**Project #21-021  
CBM Development  
Located at 2180 North 600 W**

**REPORT SUMMARY...**

<i>Project Name:</i>	CBM Development
<i>Proponent / Owner:</i>	Michael Funk / Blake Nielsen, Brookside Development
<i>Project Address:</i>	2180 N 600 W
<i>Request:</i>	Design Review Permit
<i>Current Zoning:</i>	Industrial Park (IP)
<i>Type of Action:</i>	Quasi-Judicial
<i>Hearing Date</i>	May 13, 2021
<i>Submitted By:</i>	Tanya Rice, Planner II

Staff recommends that the Planning Commission **conditionally approve** a Design Review Permit for Project #21-021, DBM Development, for one industrial building located at 2180 N 600 W, TIN #04-079-0041.

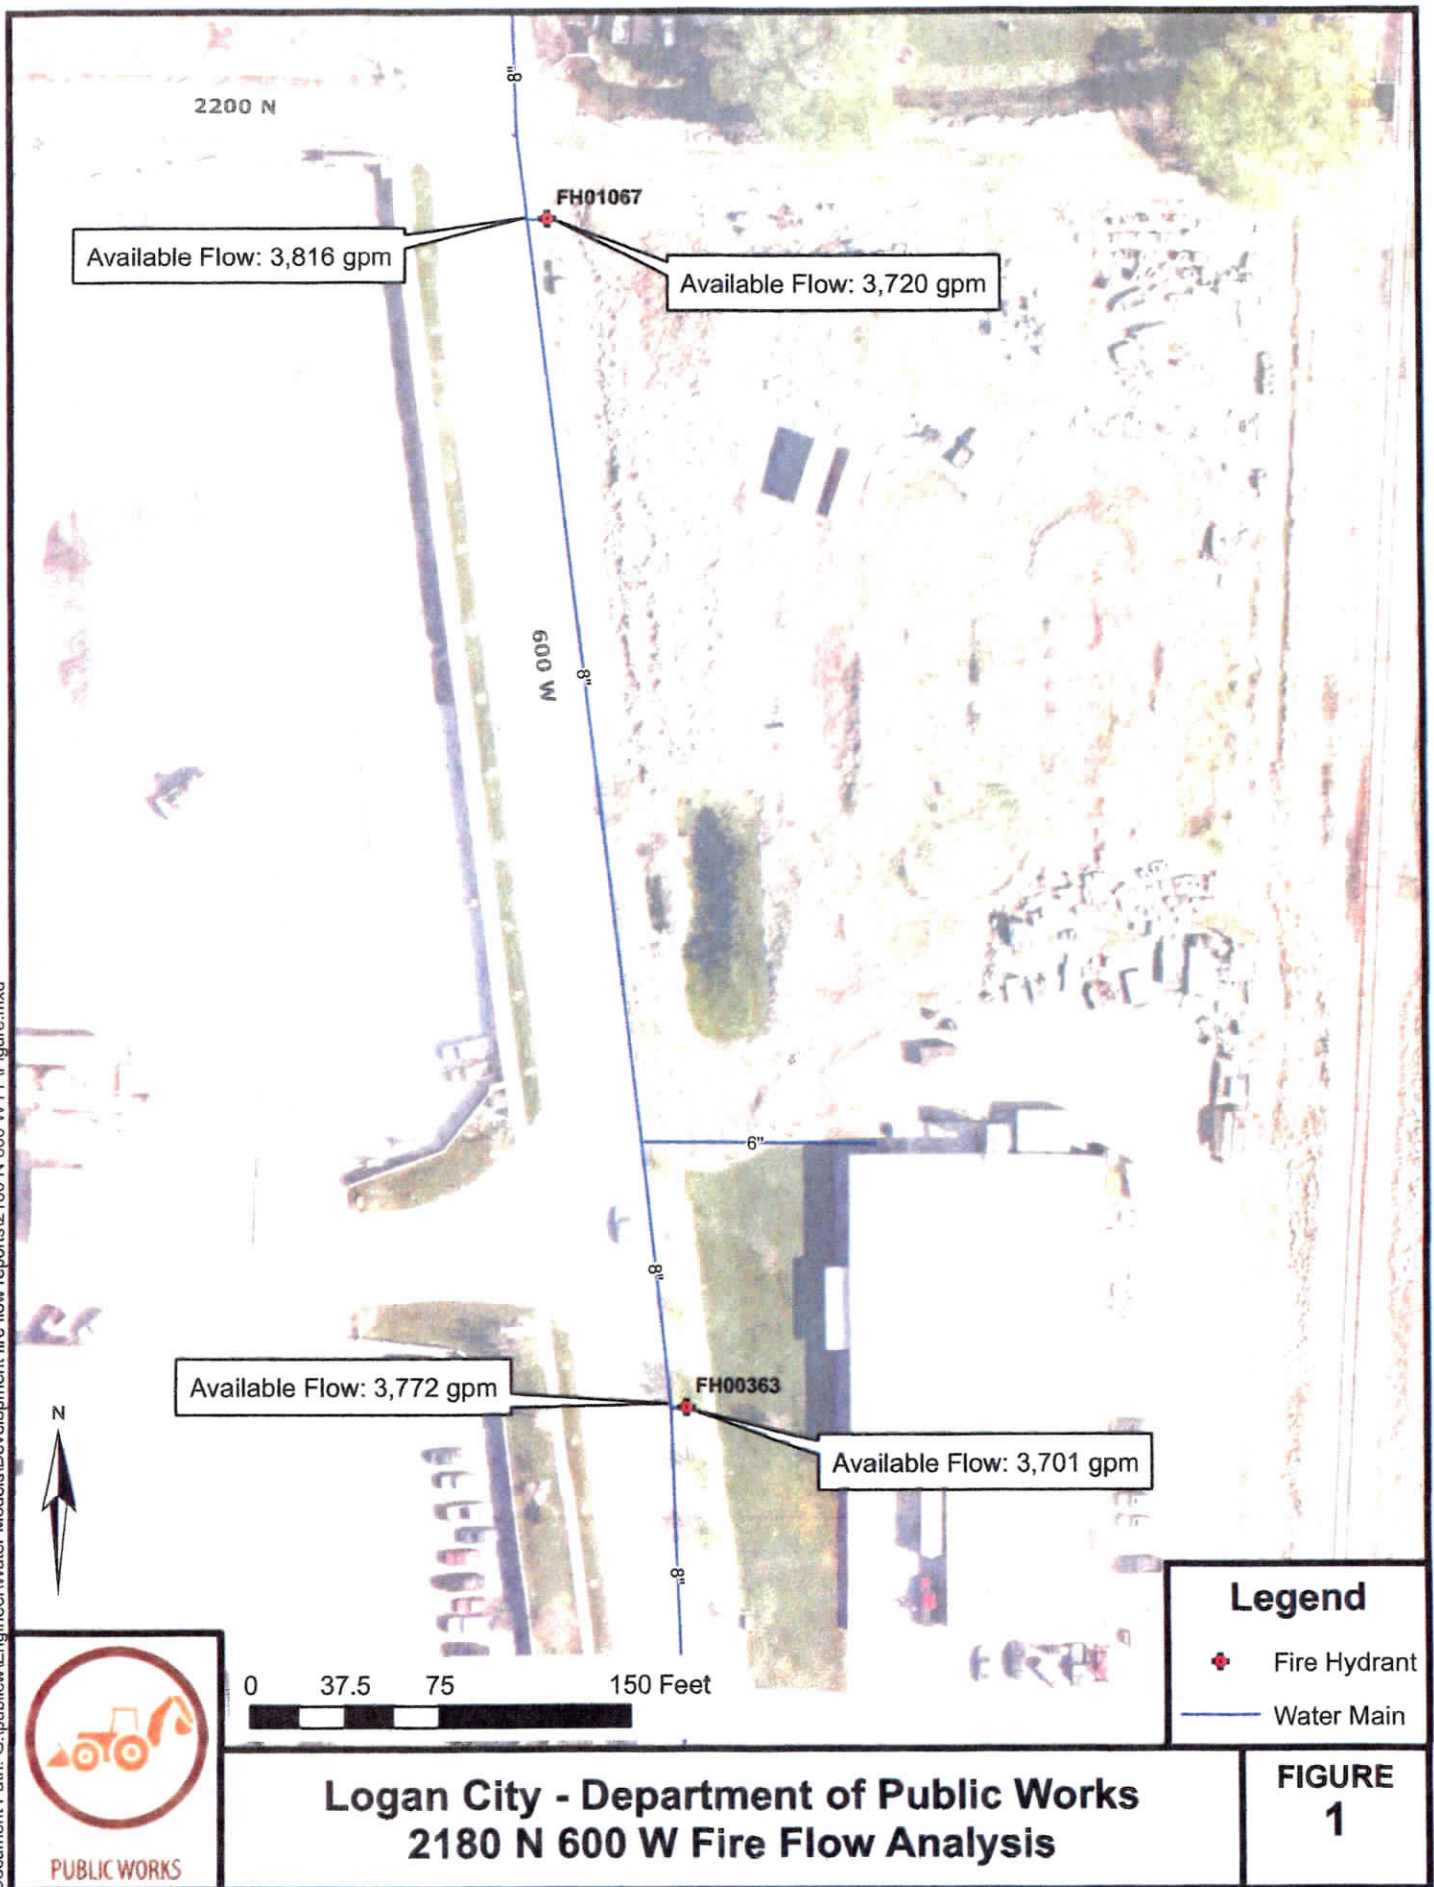
This information provides three points from which the developer's consultant can create a pressure versus flow curve to match the actual values. The actual design fire flow must be obtained from the Fire Marshall prior to completing the hydraulic analysis. Figure 1 shows the locations of this fire flow analysis.

ARCHITECTURAL  
SITE PLAN

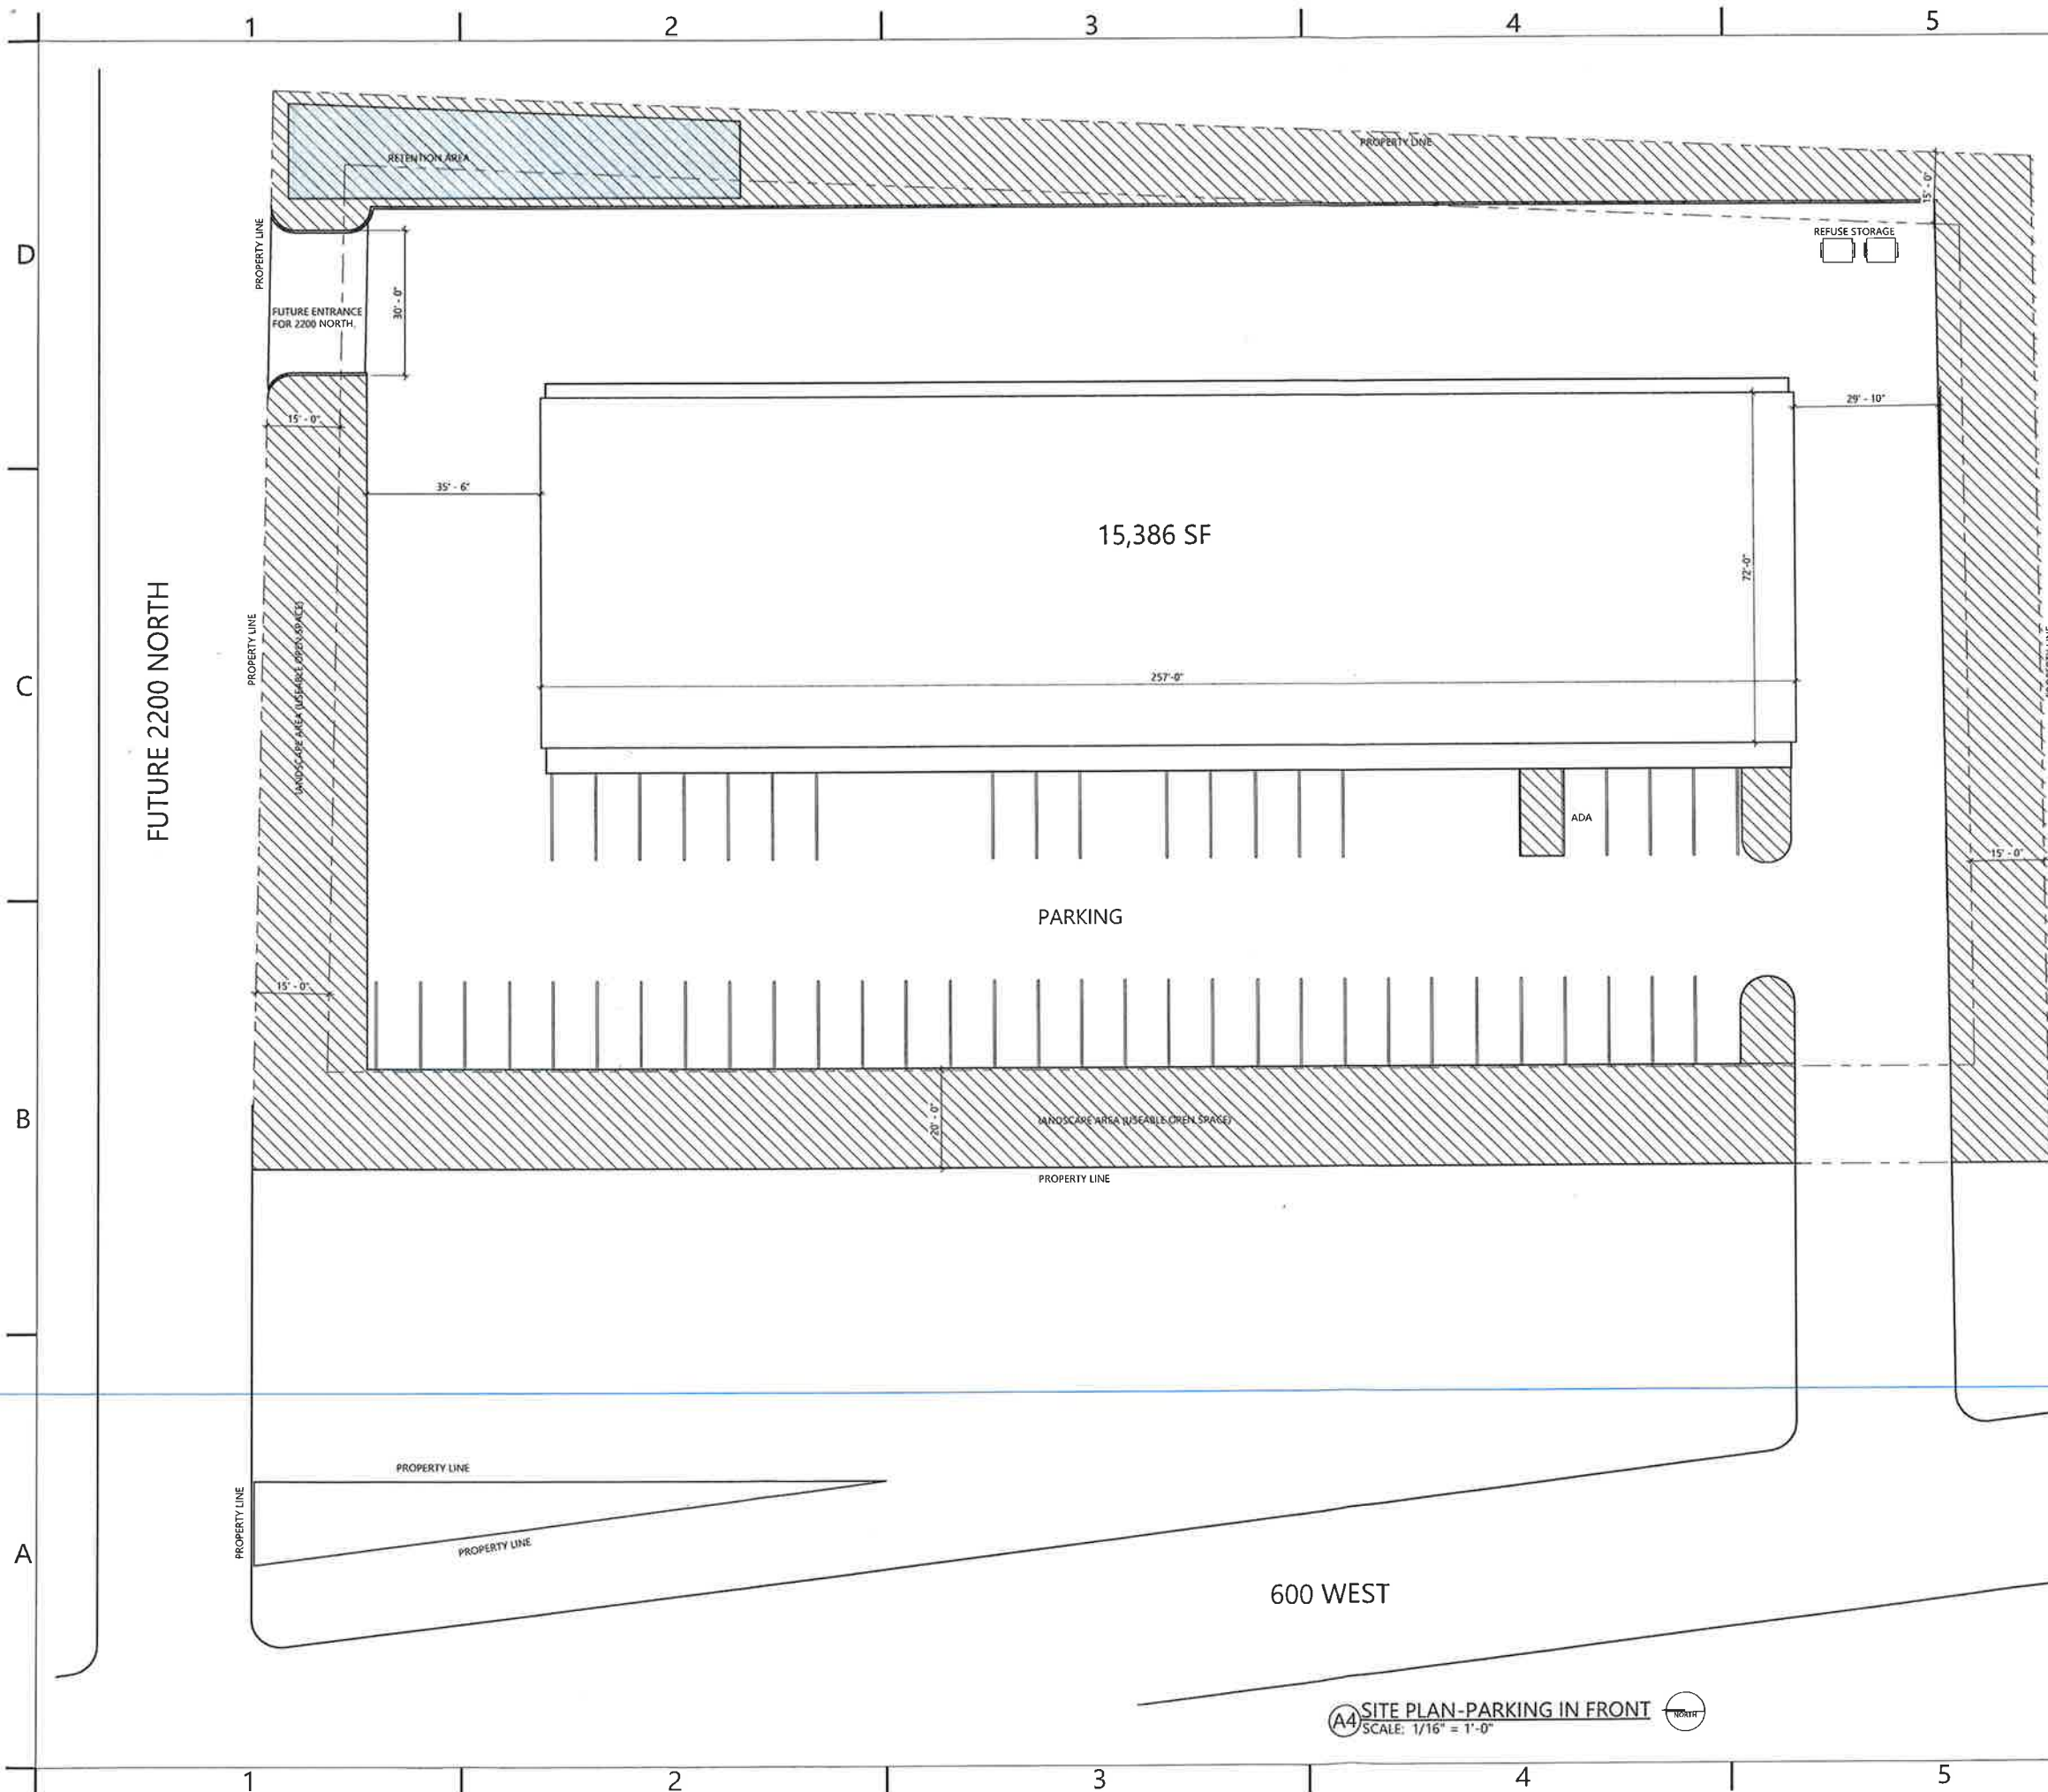
The LDC 17.31.090 requires industrial sites to include safe and convenient pedestrian circulation from the adjacent streets to buildings, parking areas and other outdoor gathering areas. The proposal does not include sidewalk connections from the building to street sidewalks. Once the 600 W driveway location and right of way issues are resolved by public works, sidewalks shall connect the building to 600 W streetscape and usable open space.

The LDC 17.30 requires walkway connections of all building entrances to one another and to adjacent streets where practicable. The proposed site plan does not include a walkway connection from the side entrances to the other building entrances. A walkway shall be constructed to connect all building entrances.

The project is proposing 47 parking stalls but has not identified a bike parking location. With the addition of bike parking, the proposal meets the minimum parking requirements.

The LDC 17.31.140 requires parking areas shall include landscape islands every 20 parking stalls. The proposed parking lot shall incorporate the required breaks to comply with the LDC.

LDC 17.30.080 requires solid waste receptacles, recycling bins, refuse storage and similar uses be enclosed and screened from view. A closure needs to be constructed proposed dumpster location. As conditioned, the onsite waste location meets the requirements of the LDC.

1. All standard conditions of approval will be recorded with the Design Review and are available in the Community Development Department.
2. Pedestrian walkways shall be constructed to connect all building entrances.

3. Parking area shall include a landscape break every 20 stalls.
4. A bike rack shall be provided to accommodate a minimum of 4 bikes.
5. A performance landscaping plan, prepared in accordance with §17.32 of the LDC, shall be submitted for approval to the Community Development Department prior to the issuance of the building permit. The plan shall include the following:
